Addendum 151 – UN Regulation No. 152

Revision 1 - Amendment 2

Supplement 2 to the 01 series of amendments – Date of entry into force: 30 September 2021

Uniform provisions concerning the approval of motor vehicles with regard to the Advanced Emergency Braking System (AEBS) for M₁ and N₁ vehicles

Figure 1

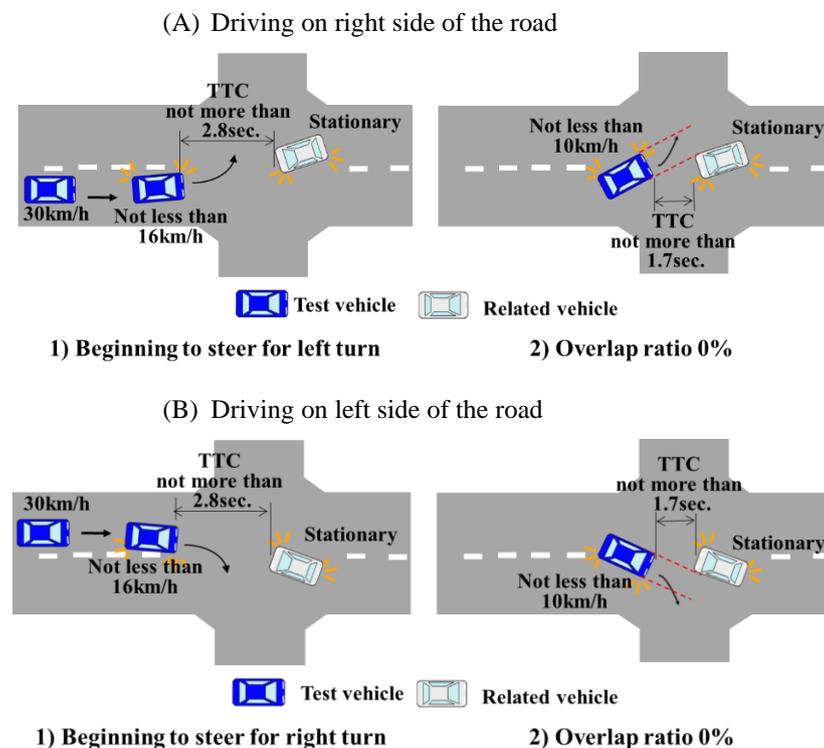
"Scenario 1

Left turn or Right turn at the intersection

- 1.1. In this scenario, the subject vehicle passes by a left turn or right turn in front of an oncoming vehicle that is stopped to make a left turn or right turn at an intersection.
- 1.2. An example of the detail scenario:
- The subject vehicle drives at a speed of 30 km/h (with a tolerance of ± 2 km/h) toward the intersection, and decelerates by braking to a speed of not less than 16 km/h at a point where the subject vehicle begins to steer left / right, and the Time To Collision (TTC) to the oncoming vehicle is not more than 2.8 seconds. When the subject vehicle turns left or right in the intersection, the speed is reduced to not less than 10 km/h, and then drives at a constant speed. The TTC to the oncoming vehicle is not more than 1.7 seconds at when the overlap ratio between the subject vehicle and the oncoming vehicle becomes 0 per cent.

Figure 2

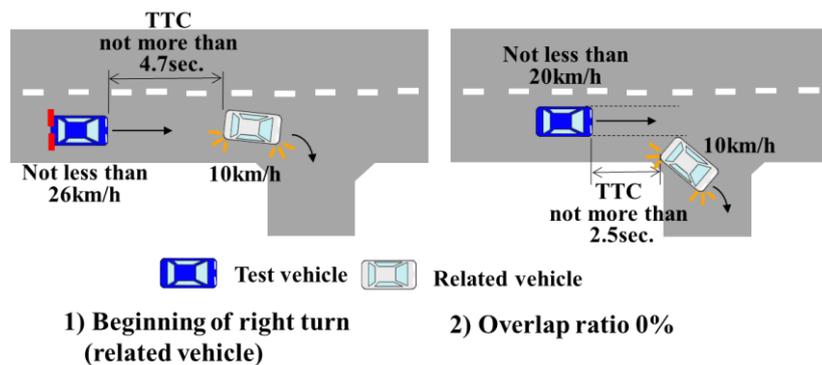
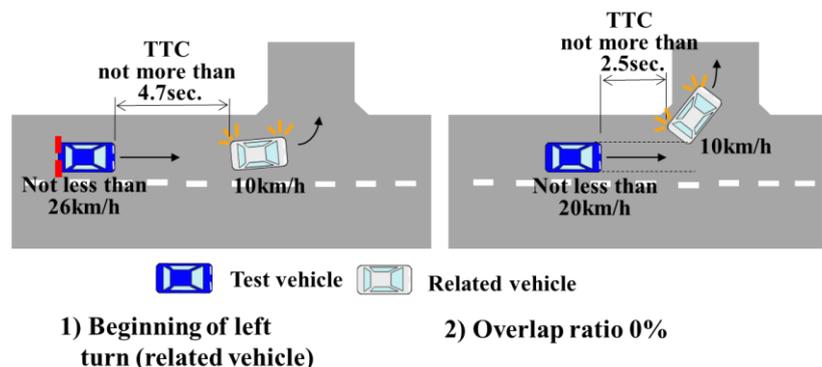
Scenario 2

Right turn or Left turn of a forward vehicle

- 2.1. In this scenario, the subject vehicle follows a forward vehicle. After that, the forward vehicle turns right or left at a corner, and the subject vehicle goes straight.

- 2.2. An example of the detail scenario:
- Both the forward vehicle and the subject vehicle drive at a speed of 40 km/h (with a tolerance of +0/-2 km/h) on the straight road. The forward vehicle decelerates by braking to a speed of 10 km/h (with a tolerance of +0/-2 km/h) in order to turn right or left at the corner, and the subject vehicle also decelerates by braking to keep appropriate distance with the forward vehicle. At when the forward vehicle begins to turn right or left, the speed of the subject vehicle is not less than 26 km/h and the TTC to the frontal vehicle is not more than 4.7 seconds. After that, the subject vehicle decelerates to a speed of not less than 20 km/h, and then drives at a constant speed. The TTC to the forward vehicle is not more than 2.5 seconds at when the overlap ratio between the subject vehicle and the forward vehicle becomes 0 per cent.

Figure 3

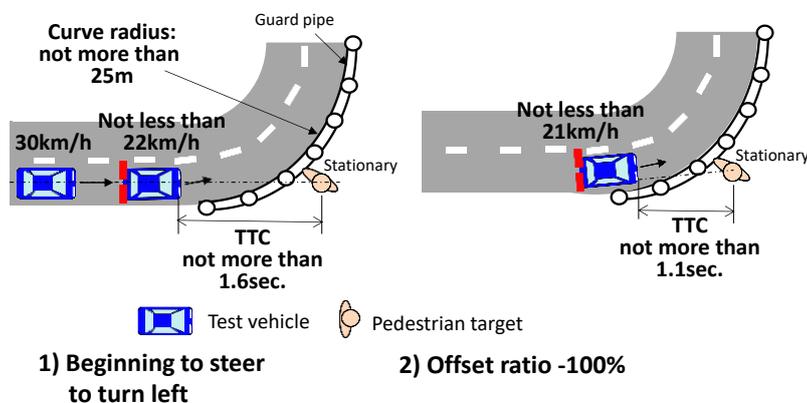
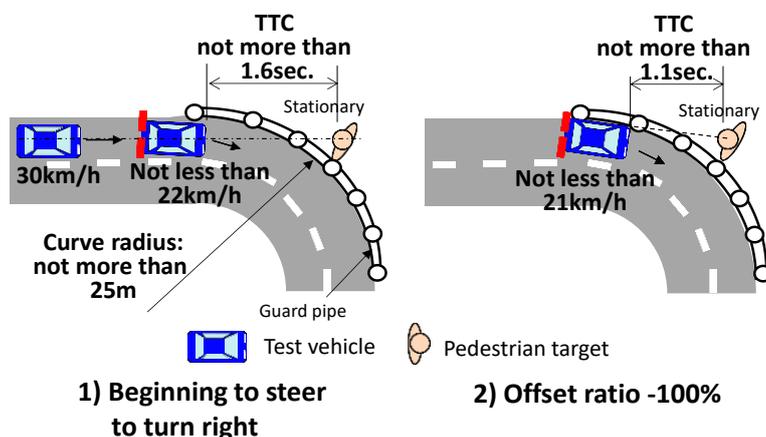
Scenario 3

Curved road with guard pipes and a stationary object

- 3.1. In this scenario, the subject vehicle drives a small radius curved road of which the guard pipes are constructed to the outer side, and a stationary vehicle (M₁ category), a stationary pedestrian target or a stationary bicycle target is positioned just outside of the guard pipes and where on the extension of the centre of the lane.

- 3.2. An example of the detail scenario:
- The subject vehicle drives at a speed of 30 (with a tolerance of +0/-2 km/h) km/h toward the curve of which the radius is not more than 25 m at the outer side of the road, and decelerates by braking to a speed of not less than 22 km/h at a point where the subject vehicle enters the curve. The TTC to the stationary object is not more than 1.6 seconds at when the subject vehicle begins to turn in the curve. In the curve, the subject vehicle drives outer lane than the centre of the road. After that, the subject vehicle continue to turn in the curve at a constant speed of not less than 21 km/h. The TTC to the stationary object is not more than 1.1 second at when the overlap ratio between the subject vehicle and the stationary vehicle becomes 0 per cent, or at when the offset ratio between the subject vehicle and the centre of the stationary pedestrian target or the stationary bicycle target becomes -100 per cent.

Figure 4

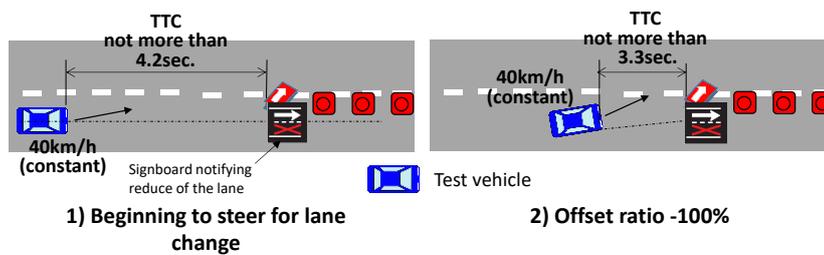
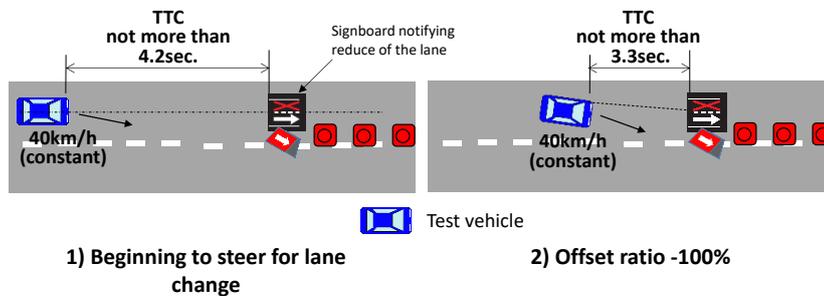
Scenario 4

Lane change due to road construction

4.1. In this scenario, the subject vehicle changes the lane in front of the signboard which is positioned in the centre of the lane and notifies the driver that the lane is reduced.

4.2. An example of the detail scenario:

The subject vehicle drives a straight road at a speed of 40 km/h (with a tolerance of +0/-2 km/h) and begins to steer in order to change the lane in front of the signboard which notifies reducing the lane. No other vehicles approach the subject vehicle. The TTC to the signboard is not more than 4.2 seconds at when the subject vehicle begins to steer. During changing the lane, the speed of the subject vehicle is constant, and the TTC to the signboard is not more than 3.3 seconds at when the offset ratio between the subject vehicle and the centre of the signboard becomes -100 per cent.
